ADDENDUM NO. 1

June 15, 2011

Duluth International Airport
New Passenger Terminal
Voluntary Air Low Emissions (VALE)
Duluth, MN 55811

Addendum No. 1

CONSTRUCTION SAFETY PHASING PLAN

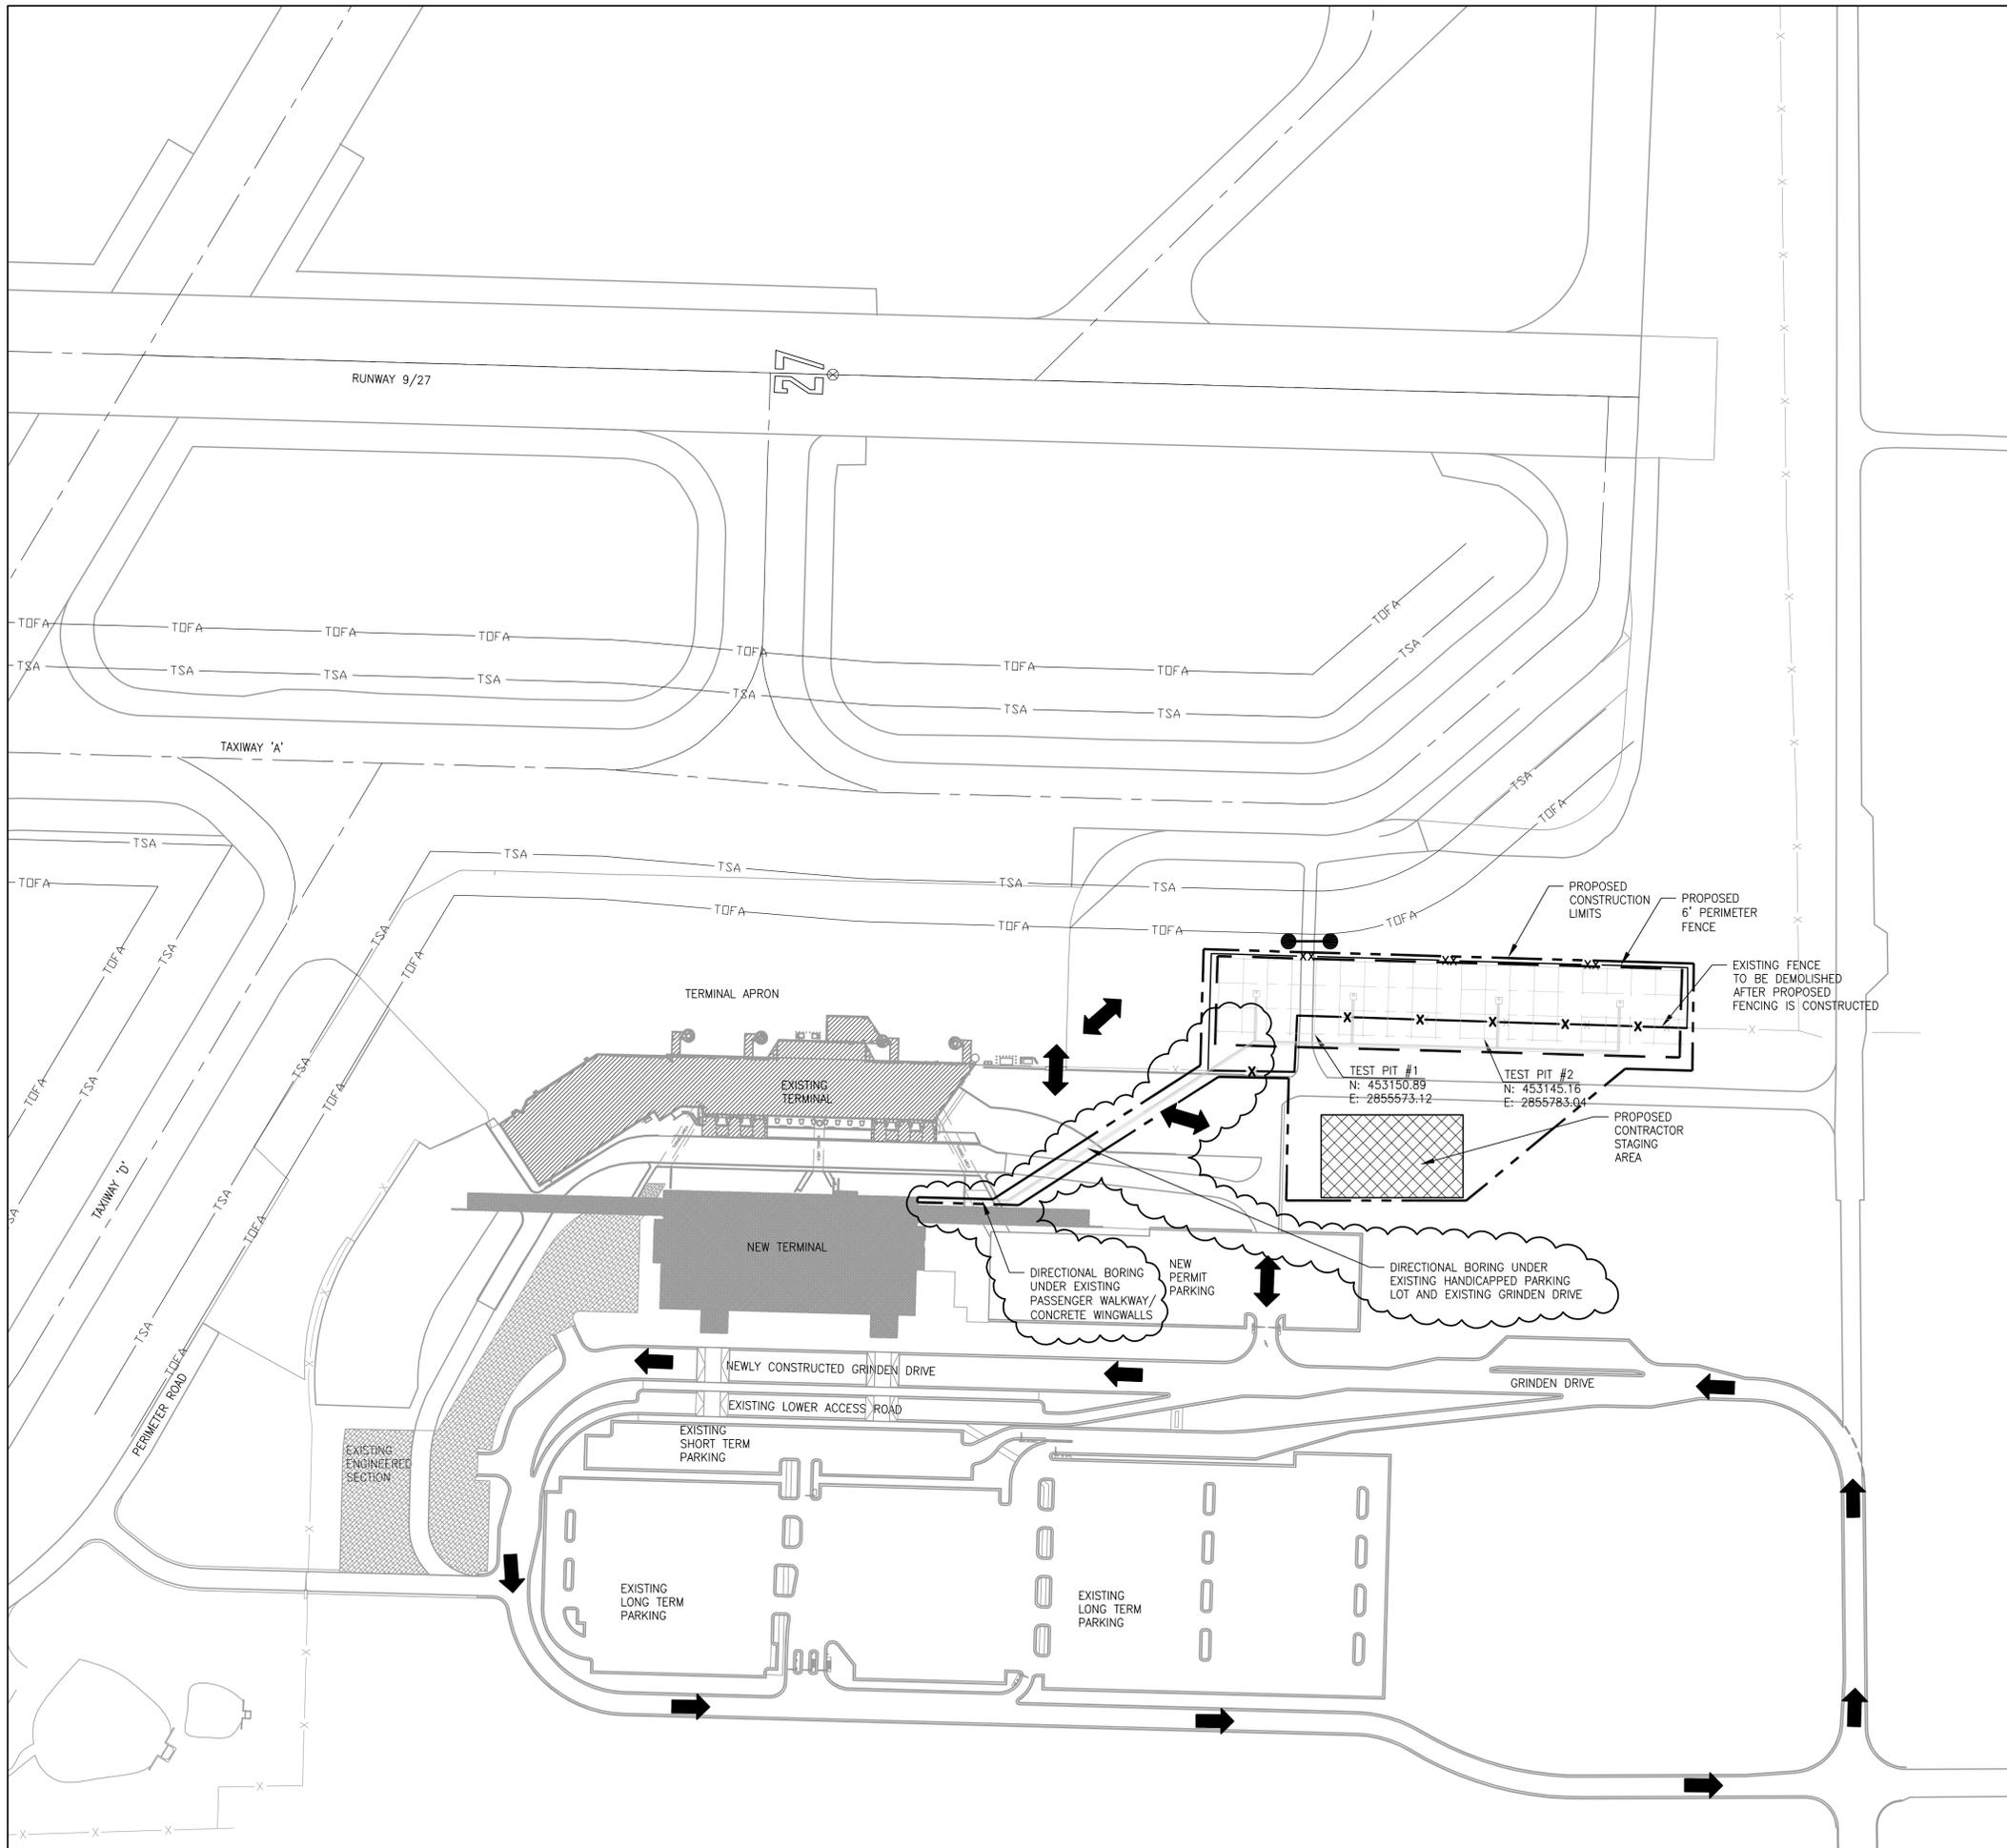
**Civil Sheet C003 – Construction Safety Phasing Plan: Revised Pipe Routing.
Sheet AS102 - Overall Site Plan: Revised Pipe Routing
Sheet A104 – Overall Roof Plan: Added Roofing Protection Pads.
Sheet A114a – Enlarged Third Floor Plan Area A: Revised Targeting; Added Note and Details.**

SHEET NUMBER
A214

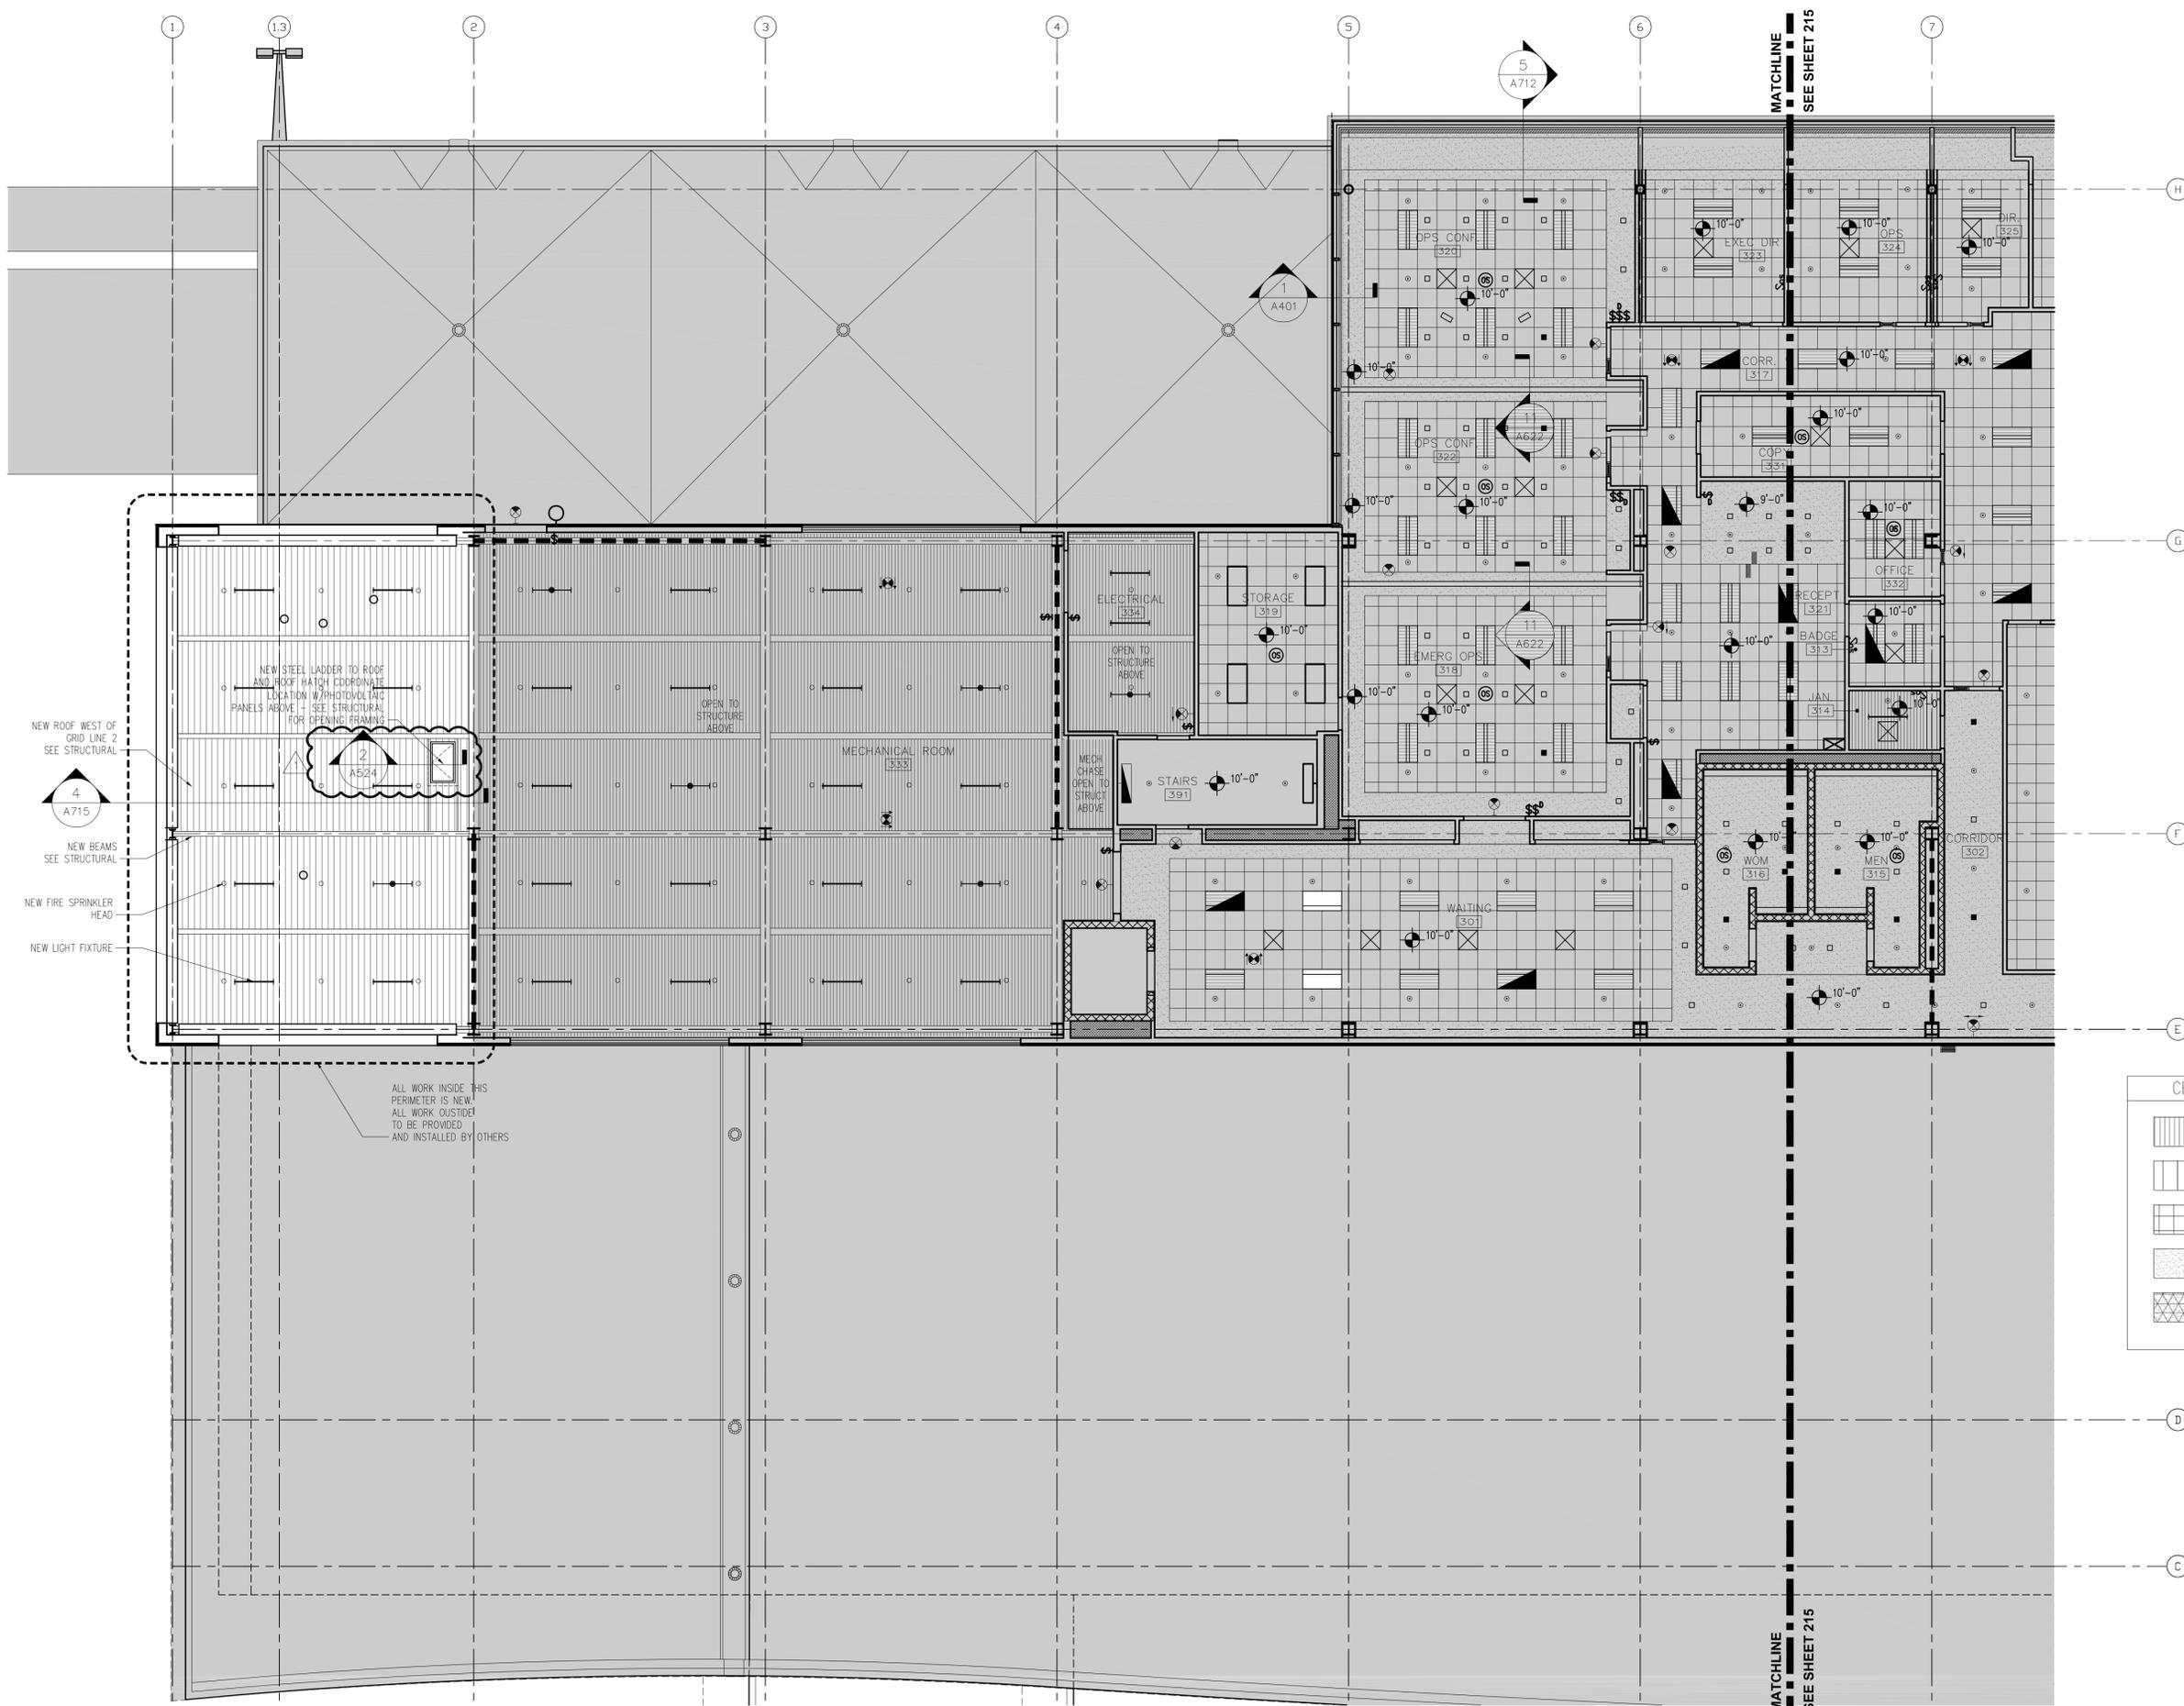
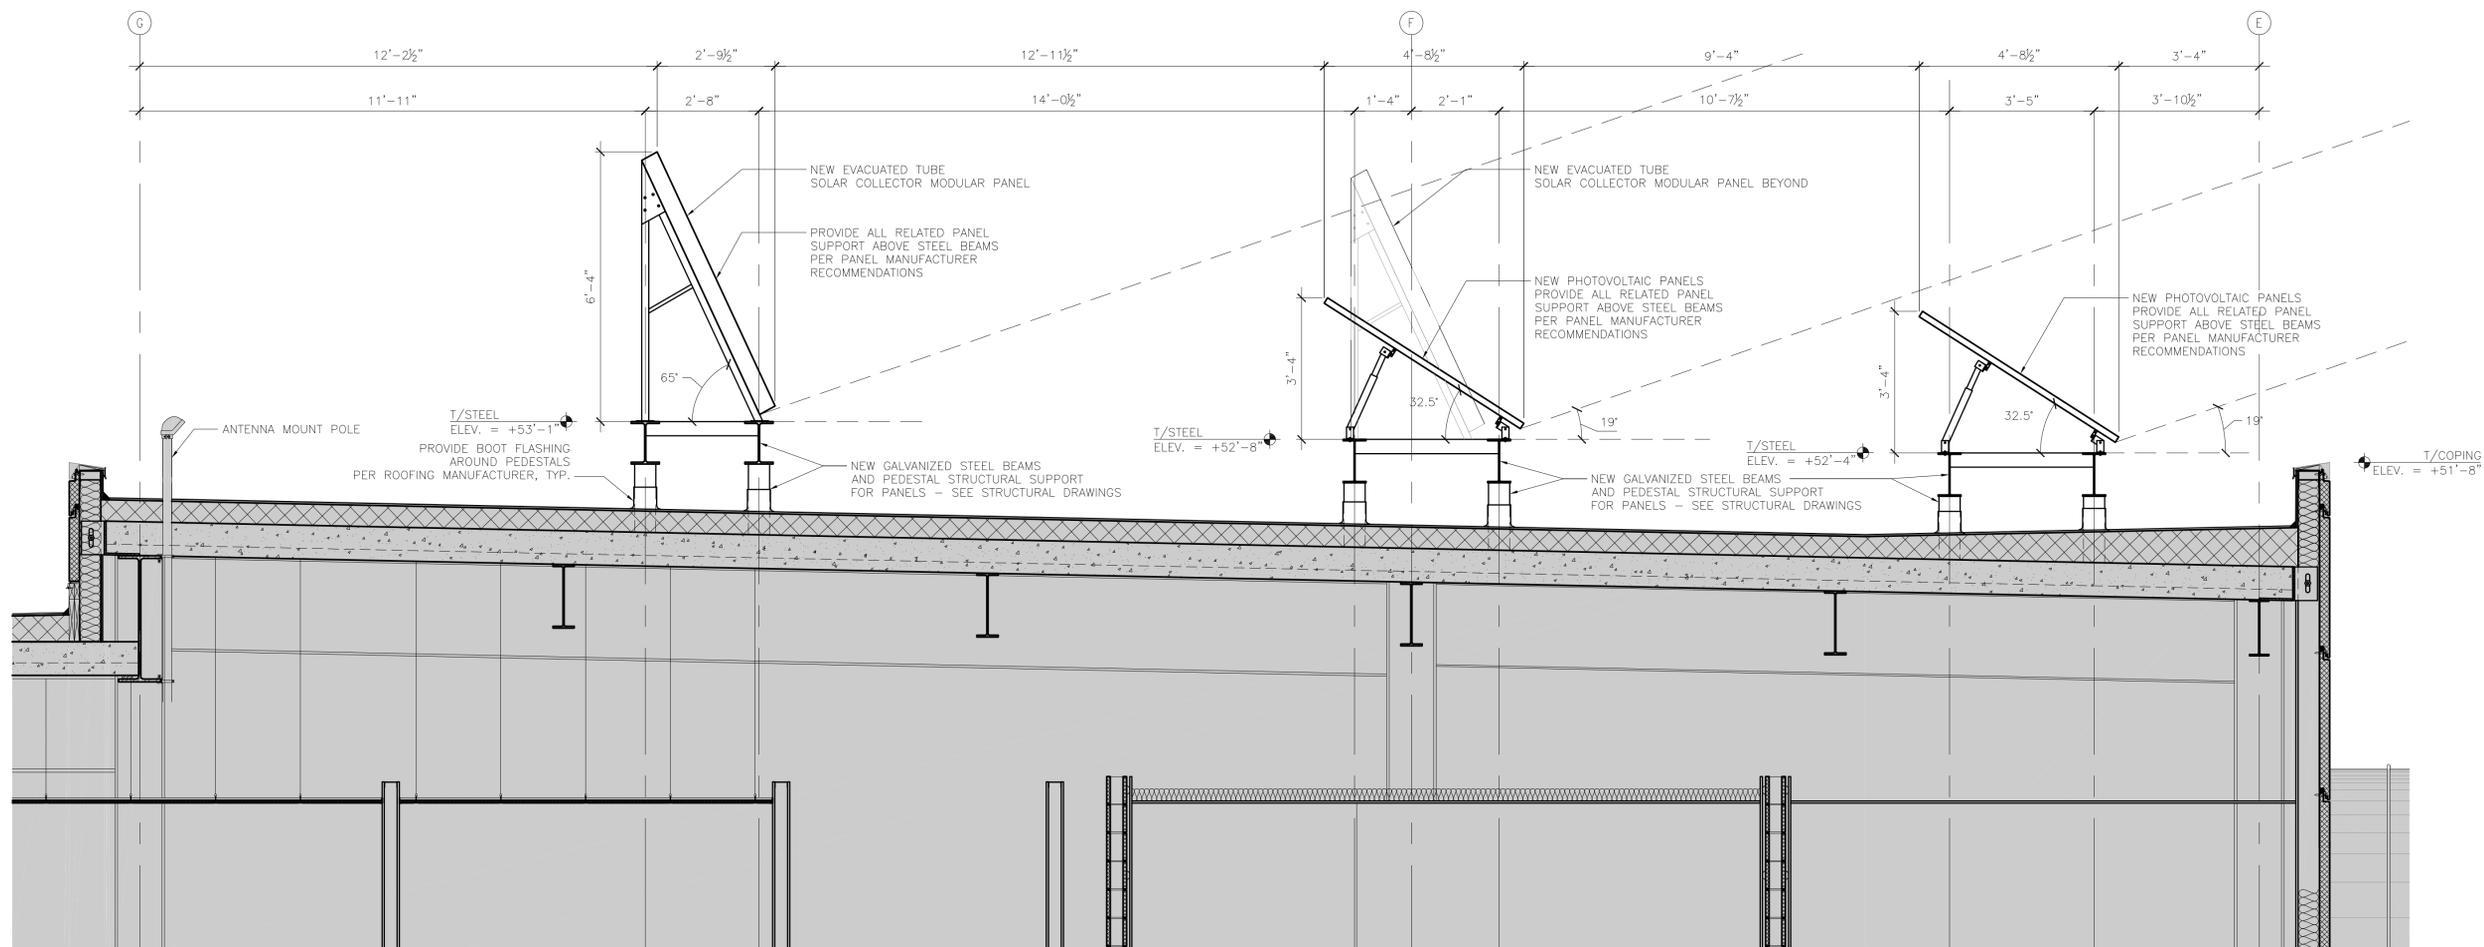
Sheet A214 – Enlarged Third Floor Reflected Ceiling Plan Area A: Revised Targeting; Added Note.

SHEET NUMBER
A524

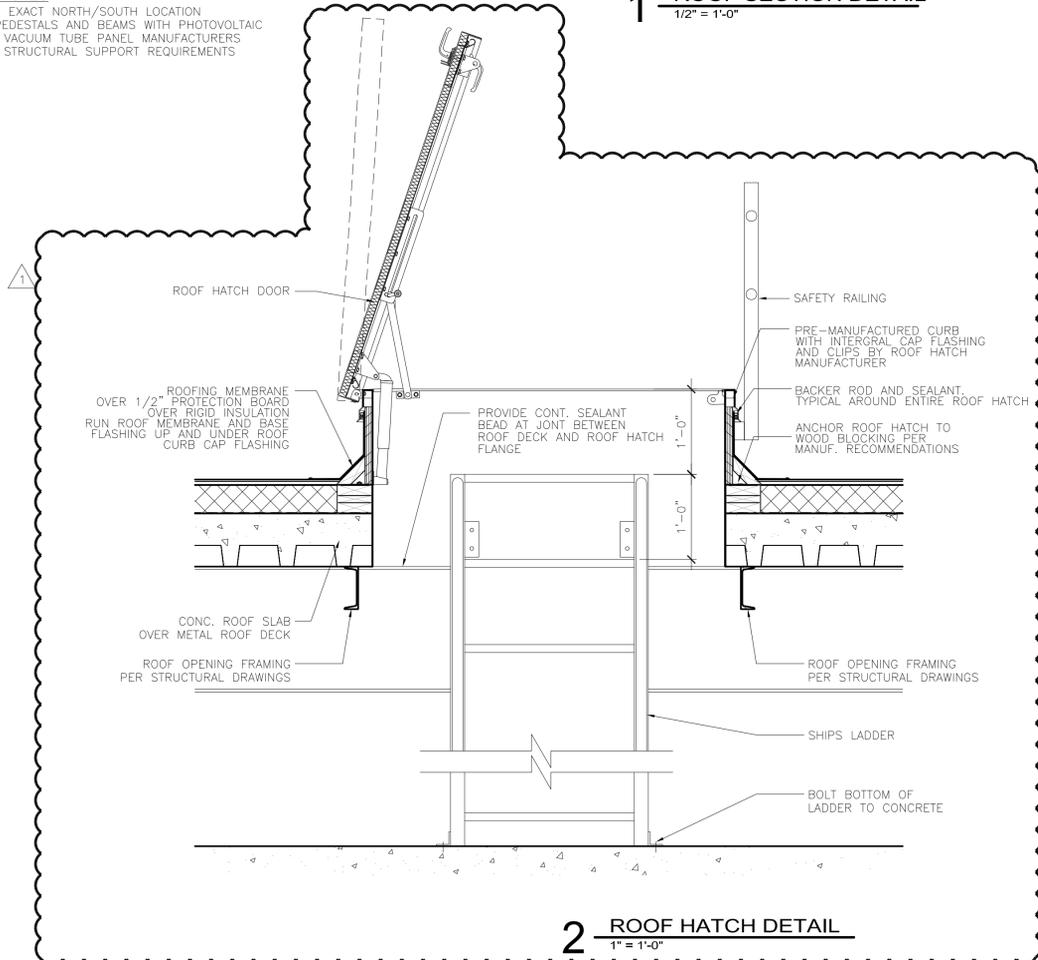
Sheet A524 – Roof Details: Added Note and Detail.
